Living Streets Canterbury

Hagley Park walking and cycling facilities

Appendix: SPOKES Submission to Hagley Park Botanic Gardens consultation in 2004

Hagley Park / Botanic Gardens Consultation

Figure 20: Suggested pathway network improvements

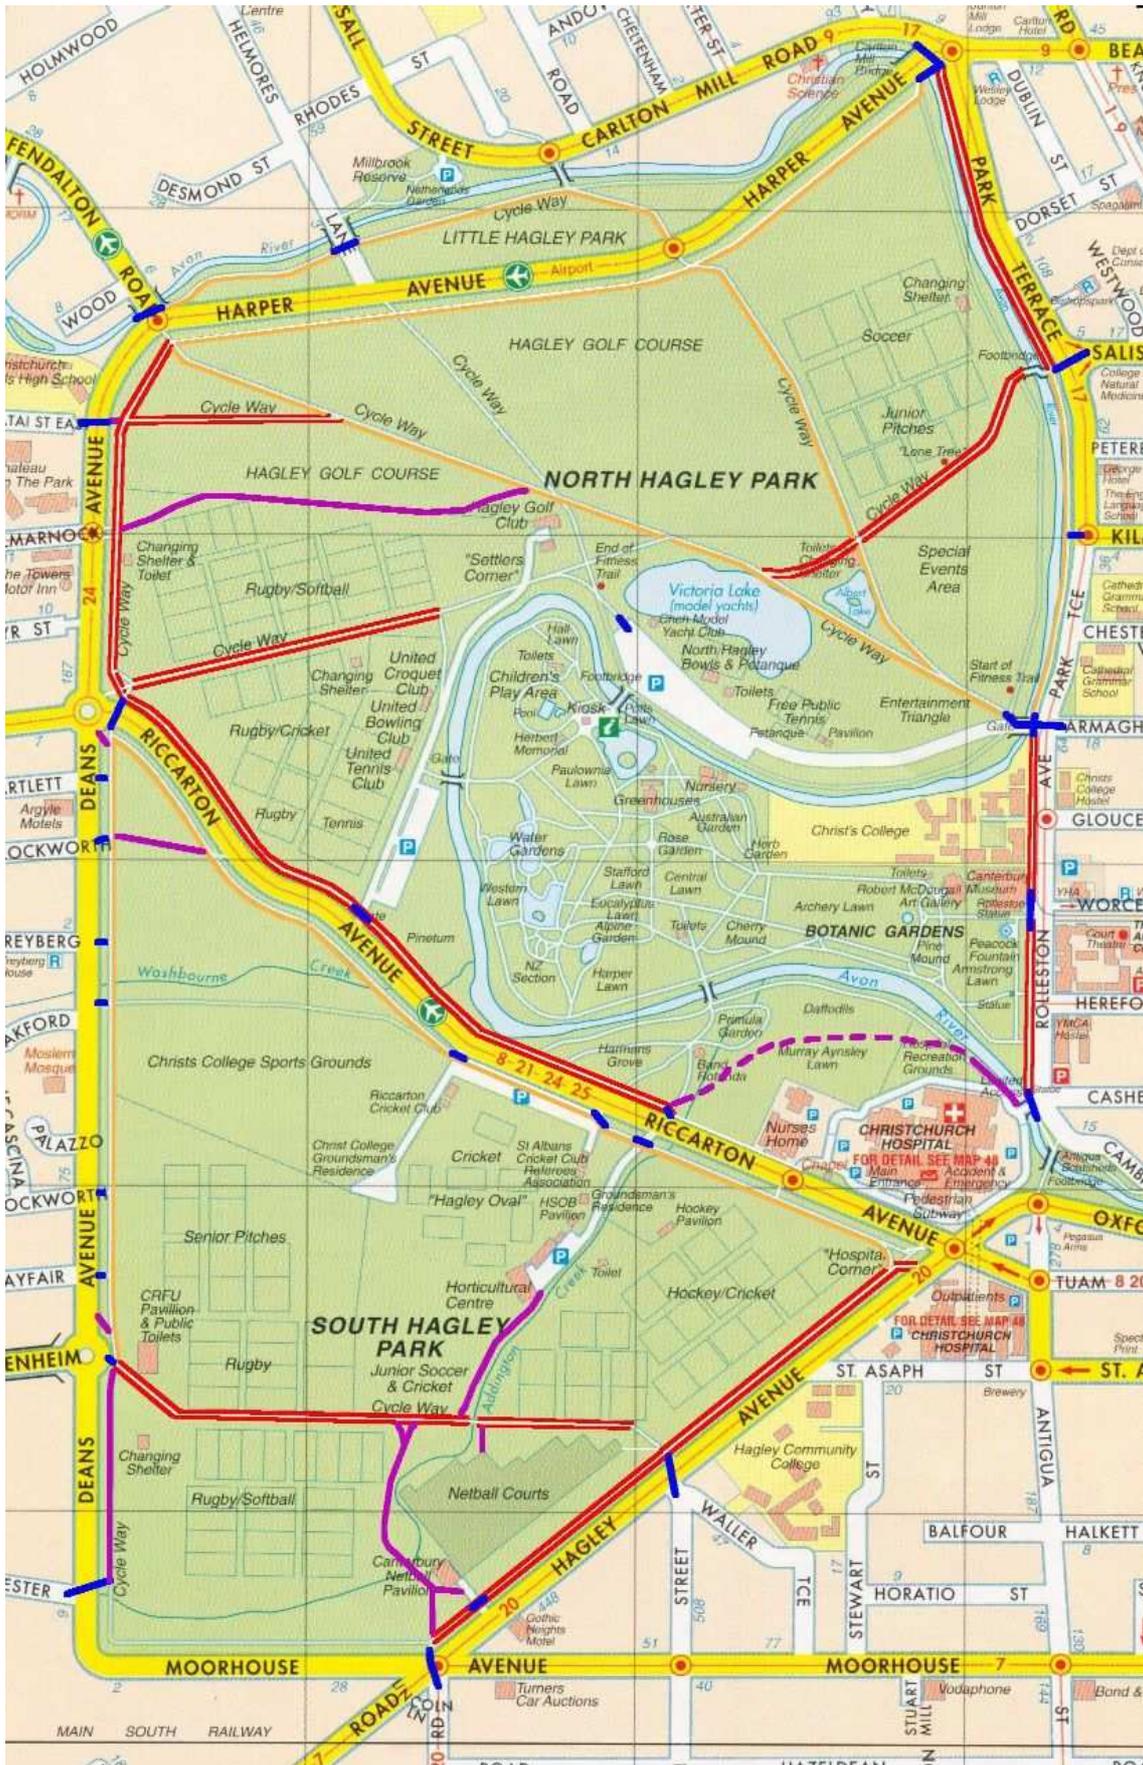
The accompanying map (see Figure 20) summarises the pathway network improvements suggested by Spokes. Clearly it is quite a comprehensive list; this merely reflects the lack of planning in this area that we feel has been evident in recent years.

Missing pathway behind Hospital

The most obvious location where a path suitable for walking and cycling is missing is between the hospital and the Avon River. Cyclists commuting from Riccarton to the central city, for whom the Riccarton Avenue corridor is the most direct route, are directed onto the road just prior to one of the more complex and demanding inner city intersections (i.e. Hospital Corner). A route around the back of the hospital and along the Avon River should be developed as a matter of priority, as it would offer a much more pleasant and safe journey into the inner city. It may well be that by doing so, many more people could be enticed to travel into the inner city by bicycle instead of by car, as this alternative route may enable people to eliminate their most frightening part of the journey by no longer having to use the Hospital Corner intersection. Spokes is aware that some of the land required for such a pathway is owned by the Canterbury District Health Board (CDHB).

It could be considered to provide a new pathway extending from Kilmarnock St due east towards the city; the boundary between the sports fields and the golf course seems a logical route. South Hagley Park could be considered for a north-south pathway along the western side of the netball courts, connecting Moorhouse/Hagley Aves – netball courts – cricket ovals – Riccarton Ave.

Figure 22: Crash data – 3 injury crashes at the toilet block junction

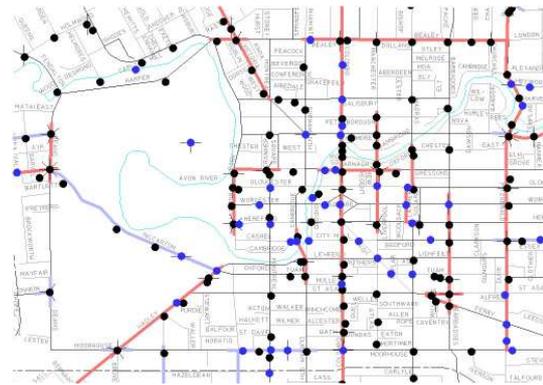
A toilet block is situated in North Hagley Park at the junction of two major pathways, totally obstructing visibility for cyclists approaching from the west or south. It has been attempted to remedy this situation by a sign saying “Cyclists Give Way to Right” (see Figure 21) and the installation of a mirror. Spokes is not convinced that these measures are sufficient, and indeed a look at a plot of injury cycle crashes shows three reported crashes (see Figure 22) – in the middle of Hagley Park! We find this situation unacceptable and suggest that the junction should be located away from the toilet block (both paths could easily be shifted north and east to achieve this).
